2275MUX/MUXE DISK MULTIPLEXER

ECO NO. 47057

PART NO.	210-8824	DESCRIPTION	2275 MUX MASTER
DWG NO.	8824	PEP #	PEP# HU
MODEL NO.	2275 MUX	PEP #	
CLASS	I (11) III		PRIMARY

ECO NO. 525.2
SHEET 1 OF 6

8024-1 COMPONENT SIDE

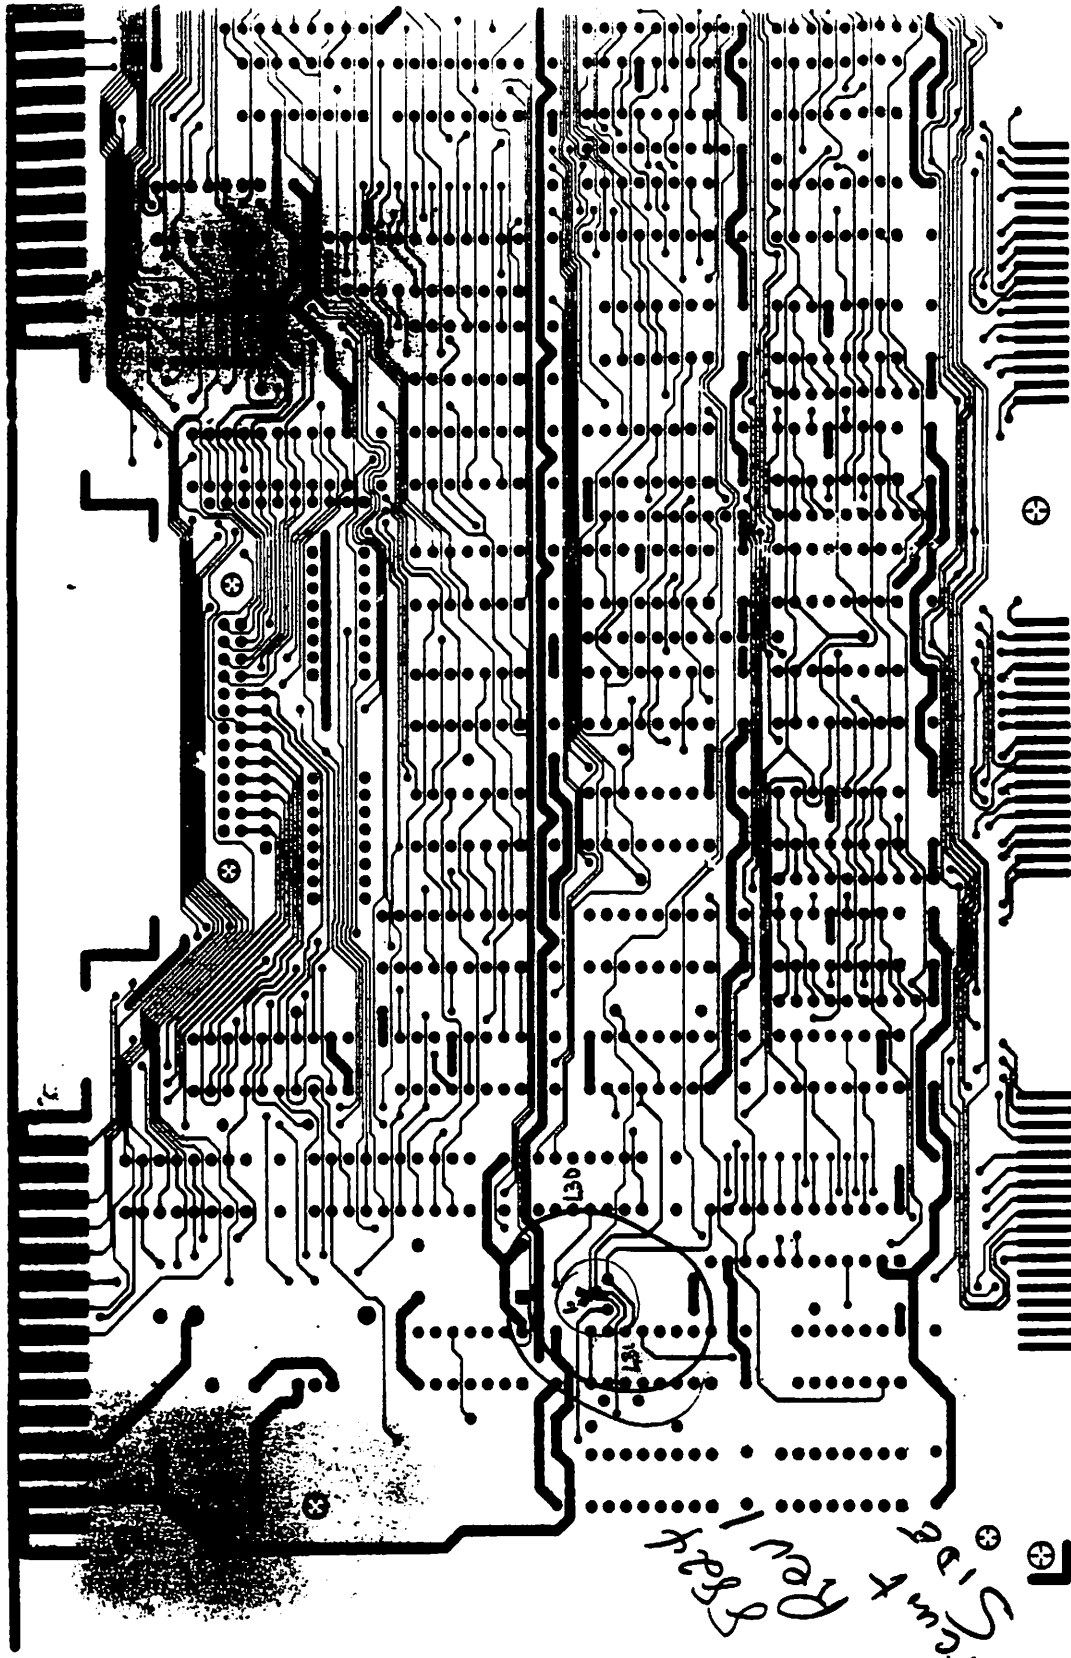
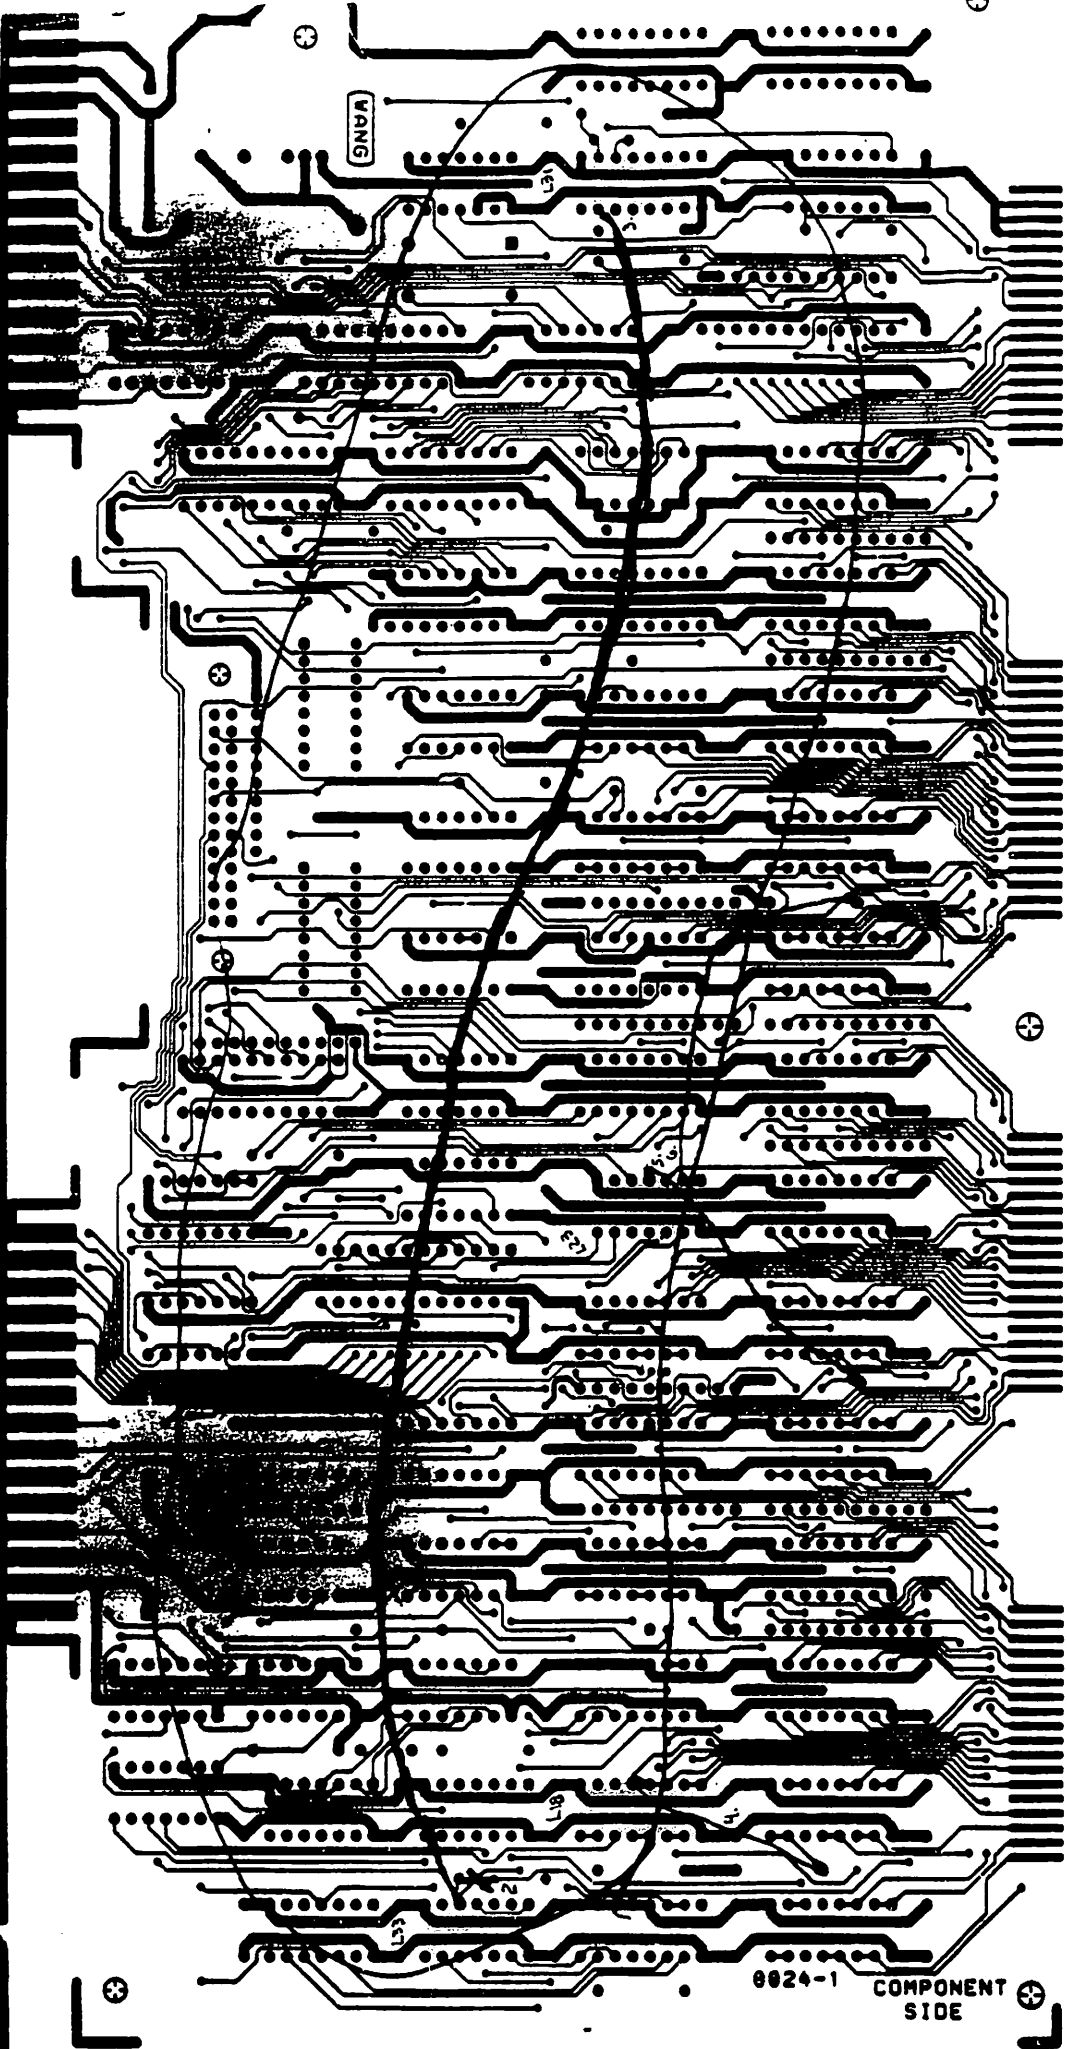
Rev 1 artwork errors. All other documentation is correct.

1. Remove etch on circuit side between L30 pin 13 and L31 pin 10.
2. Remove etch on component side leading to L33 pin 5.
3. Add etch from L31 pin 10 to L33 pin 5.
4. Tie feedthru for top of R1 to L18 pin 5.
5. Tie feedthru for top of R4 to L23 pin 4.
6. Tie feedthru for top of R7 to L23 pin 2.

PAGE 3
ECO 58244
210-8824 R2

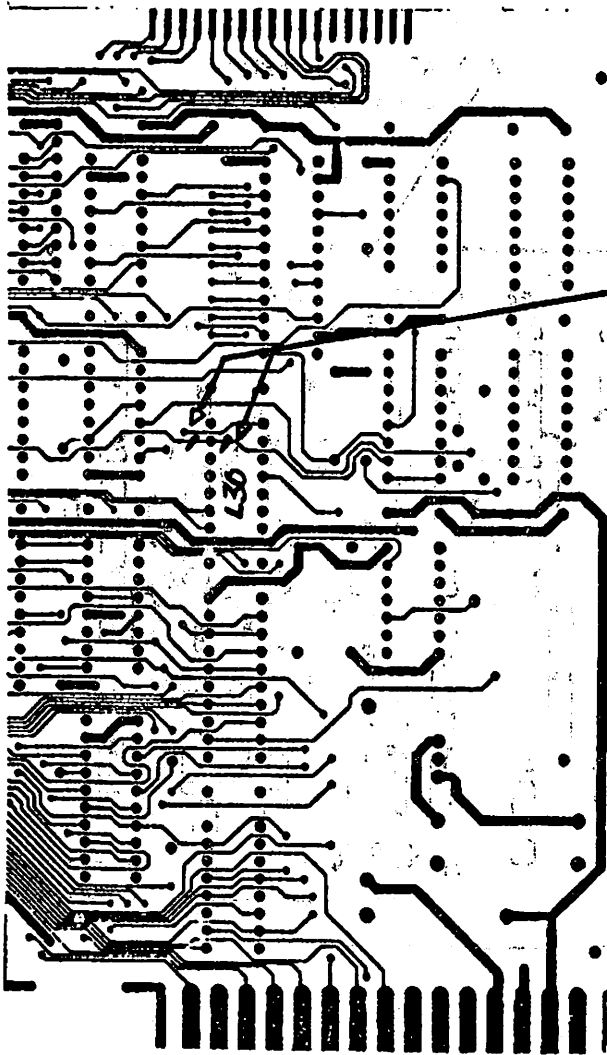
2.) ADD WIRE FROM
L10-7 TO L26-5.

3.) ADD WIRE FROM
L6-7 TO L22-5.

4.) ADD WIRE FROM
L2-9 TO L18-5.

1.) ADD WIRE FROM L31-10 TO L33-5.

- Rework Artwork 2 Board as follows:
On circuit side cut etch to L30 Pin 13 on both sides of Pin 13.
Add wire from L31 Pin 10 to L33 Pin 5.
add wire from L2 Pin 9 to L18 Pin 5.
add wire from L6 Pin 7 to L22 Pin 5.
add wire from L10 Pin 7 to L26 Pin 5.
- Make following correction to schematic, sheet 3 of 3, loc C12:
Line from L2 Pin 10 (3I2) should tie to line between L30 Pin 2 and L18 Pin 5 (3C12). It should not connect to L18 Pin 7 (3C12).

PAGE 2
CIRCUIT SIDE
ECO 58244
210-8824 R2

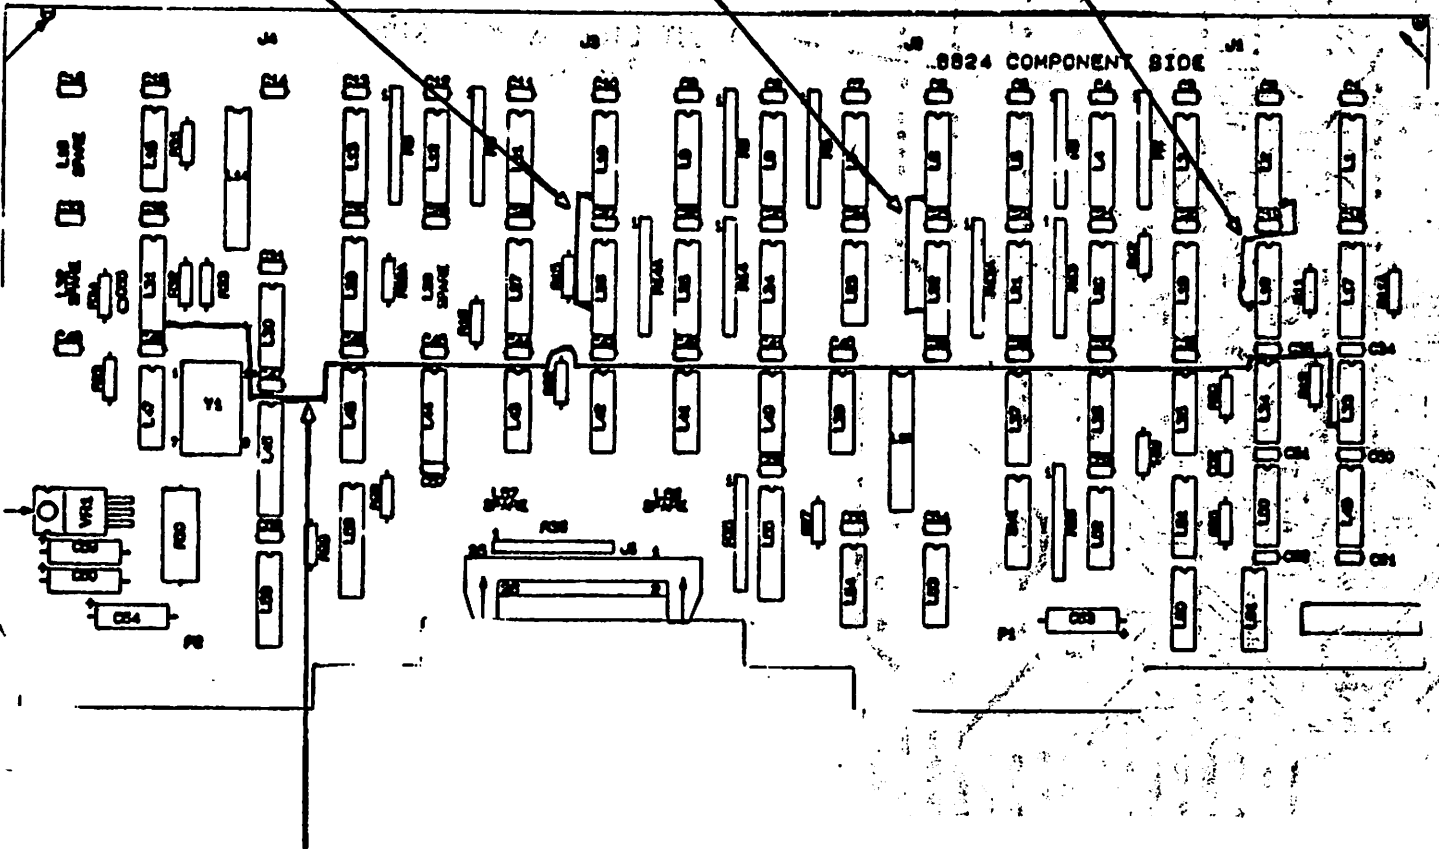
1.) CUT ETCH ON BOTH SIDES
OF L30-13.
